NRC-03-077 10 CFR 50.90

July 24, 2003

KEWAUNEE NUCLEAR POWER PLANT
DOCKET 50-305
LICENSE No. DPR-43
RESPONSE TO REQUEST FOR ADDITIONAL INFORMATION RELATED TO NMC REQUEST FOR THE USE OF GOTHIC 7 FOR THE KEWAUNEE NUCLEAR POWER PLANT CONTAINMENT DESIGN BASIS ACCIDENT ANALYSES

RESPONSE TO
REQUEST FOR ADDITIONAL INFORMATION
GOTHIC 7.0
TAC MB6408

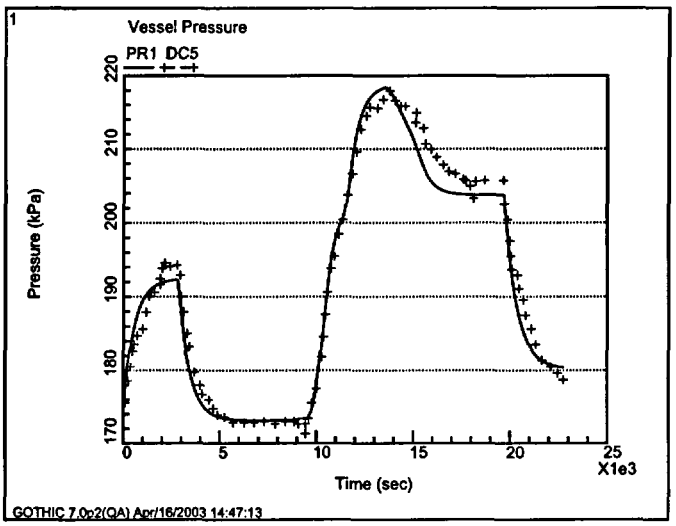
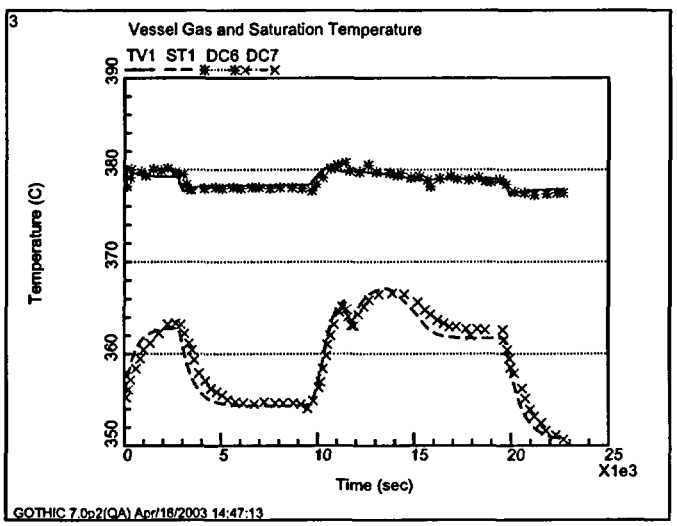
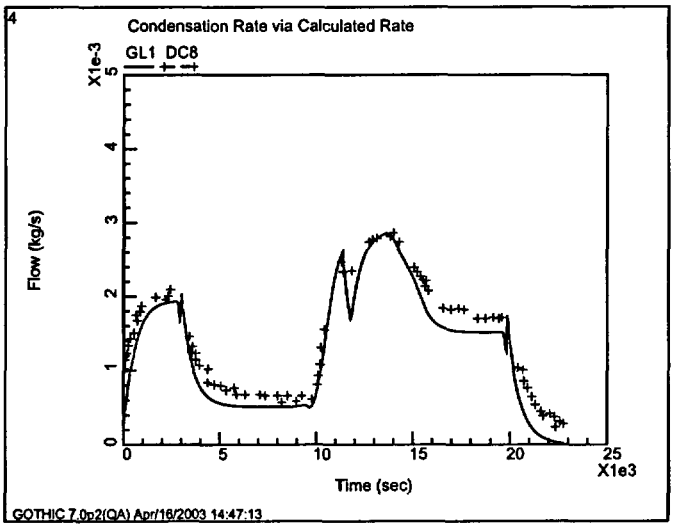
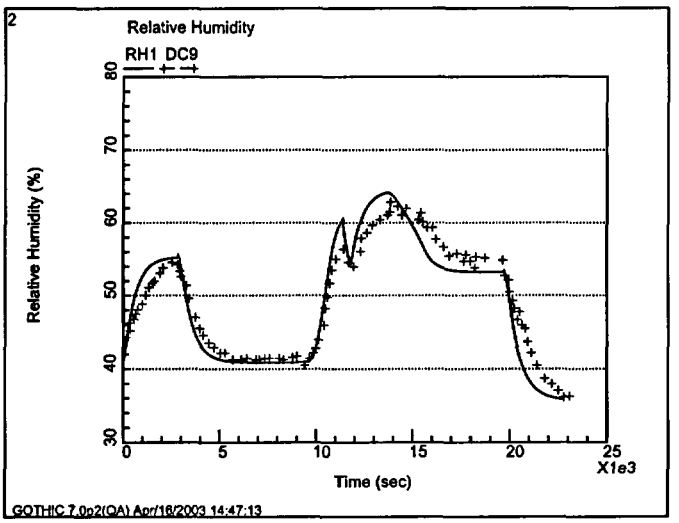
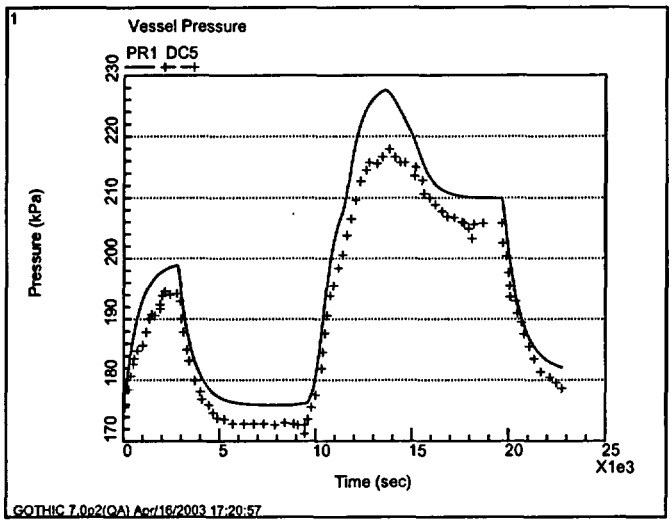
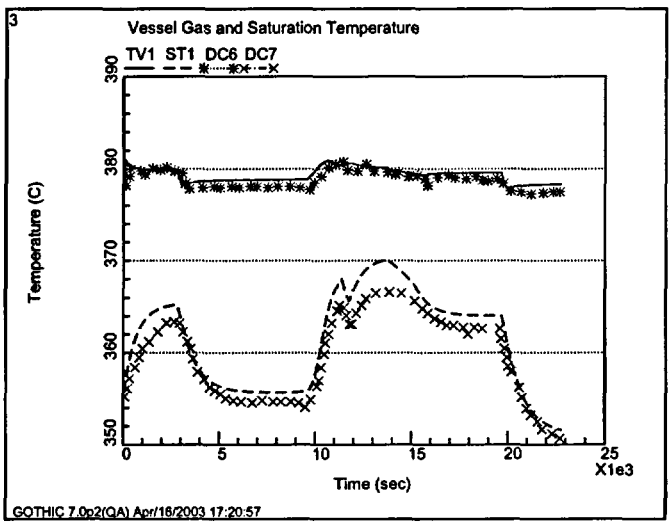
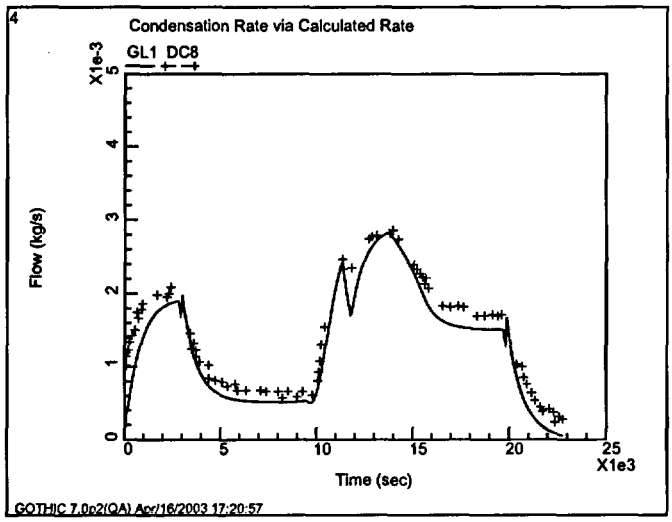
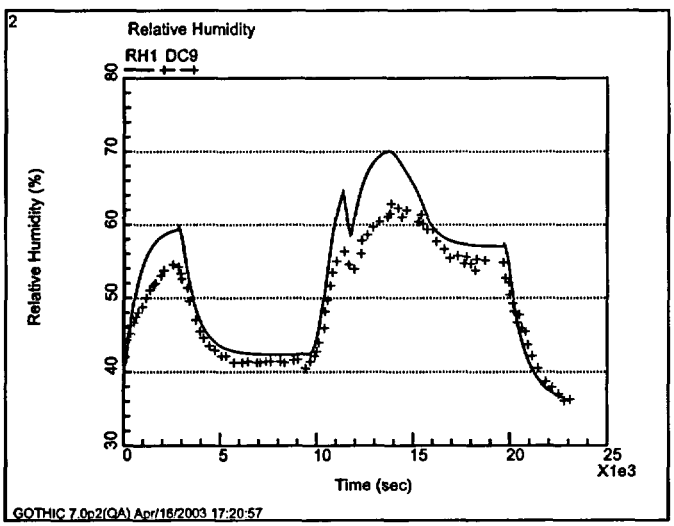
(c) Phebus test FPT0[3] is an experiment performed by the Institut de Protection et de Surete Nucleaire (ISPN) which included the measurement of thermal hydraulic conditions in a vessel with a superheated atmosphere. The NRC CONTAIN 2.0 code, using the heat mass transfer analogy, compares favorably with data from this test without a mist diffusion layer model[4]. Have comparisons been made between GOTHIC 7.0 with the results of this test? If no comparisons with this test have been made using GOTHIC 7.0, please perform a GOTHIC 7.0 calculation of FPT0. [The CONTAIN 2.0 input data are provided as an attachment to these questions for any assistance these data provide.]

Response to 7(c): The Phebus test FPT0 had not been used to qualify the GOTHIC MDLM option. Using the CONTAIN 2.0 input provided with the RAI, a GOTHIC model was constructed for Phebus test FPT0. The model was similar to the CONTAIN model, using a single lumped volume for the containment and a small sump volume to collect the condensate. Results for the pressure, temperature, humidity and condensation rate are shown in Figures 1 through 4. In these figures, the symbols represent the measured Phebus data as digitized from the figures presented in [16] and the lines represent the GOTHIC results. The original test report was not available so we do not know the accuracy of the test measurements or the accuracy of the test description. There is generally good agreement for all parameters, probably within the uncertainty in the experiment. Most of the difference between the measured and predicted pressure can be eliminated by a change in the cold wall temperature of 0.5C or a change in the initial humidity of 1%. Results are also presented (Figures 5-8) for the same test case with the conservative factor used for the Kewaunee analysis (0.717) applied to the MDLM heat and mass transfer coefficients. The pressure is significantly over predicted at all conditions. There is a smaller relative impact on the vapor temperature but the predicted temperature generally exceeds the measured value. There is only small changes to the condensation rate. For this test, when the conditions are steady, the condensation rate must match the steam injection rate to obtain the steady conditions. Therefore, the condensation rate at the steady conditions is the same with or without the multiplier. However, to achieve the same condensation rate with the conservative multiplier, the steam concentration must be higher as evidenced in the graph for the humidity. This is also reflected in the higher pressure and temperature when the conservative multiplier is applied.
